Inland Transport Committee

World Forum for Harmonization of Vehicle Regulations**Working Party on Passive Safety****Seventy-third session**

UN Regulation No. 16 (Safety-belts)**Proposal for the 09 Series of Amendments to UN Regulation
No. 16 (Safety-belts)****Submitted by the expert from France ^{*}, ^{**}**

1. Arrangements of the vehicle approval marks concerning the installation of safety-belts Model A
(See paragraph 5.2.4. of this Regulation)

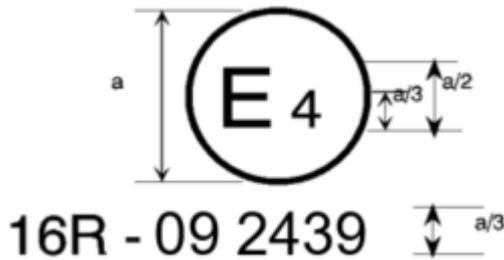
The above approval mark affixed to a vehicle shows that the vehicle type concerned has, with regard to safety-belts, been approved in the Netherlands (E 4) pursuant to Regulation No. 16. The approval number indicates that the approval was granted according to the requirements of Regulation No. 16 as amended by the **09** series of amendments.

Model B

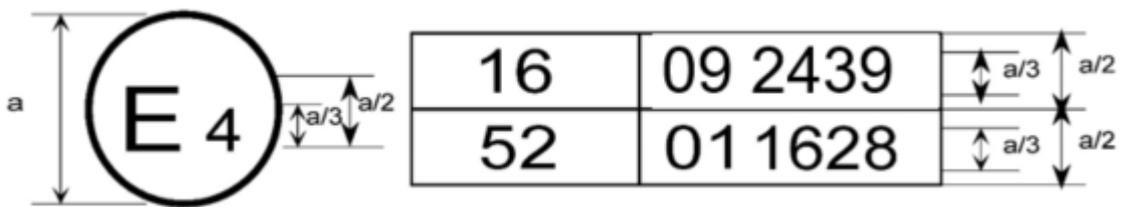
The above approval mark affixed to a vehicle shows that the vehicle type concerned has been approved in the Netherlands (E 4) pursuant to Regulations Nos. 16 and 52. ¹ The approval numbers indicate that, at the dates when the respective approvals were given, Regulation No. 16 included the **09** series of amendments and Regulation No. 52 the 01 series of amendments.

2. Arrangements of the safety-belt approval marks (See paragraph 5.3.5. of this Regulation)

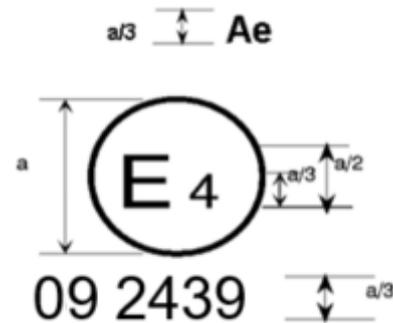
The belt bearing the above approval mark is a three-point belt ("A"), fitted with an energy absorber ("e") and approved in the Netherlands (E 4) under the number 082439, this Regulation already incorporating the 06, 07, ~~08~~ **08** or **09** series of amendments at the time of approval.

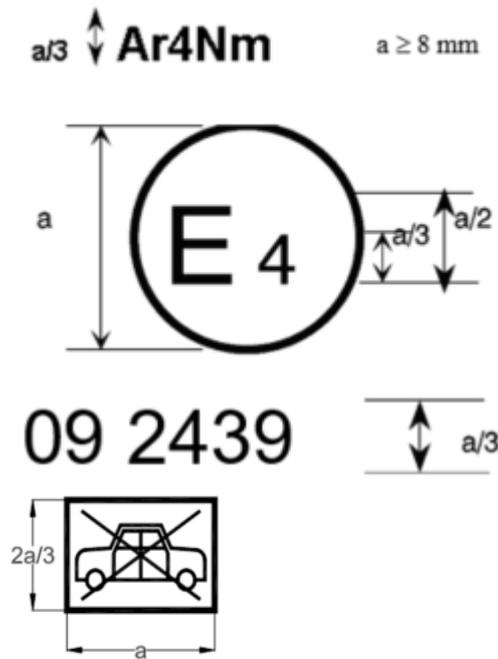
The belt bearing the above approval mark is a special type belt ("S"), fitted with an energy absorber ("e") and approved in the Netherlands (E 4) under the number 0822439, this Regulation already incorporating the 06, 07, ~~08~~ **08 or 09** series of amendments at the time of approval.

The belt bearing the above approval mark is part of a restraint system ("Z"), it is a special type belt ("S") fitted with an energy absorber ("e"). It has been approved in the Netherlands (E 4) under the number 0824391, this Regulation already incorporating the 06, 07, ~~08~~ **08 or 09** series of amendments at the time of approval.

The belt bearing this type approval mark is a three-point belt ("A") with a multiple-sensitivity ("m") type 4N ("r4N") retractor, in respect of which type approval was granted in the Netherlands ("E 4") under number 082439, this Regulation already incorporating the 06, 07, ~~08~~ or 09 series of amendments at the time of approval. This belt shall not be fitted to vehicles of category M1.
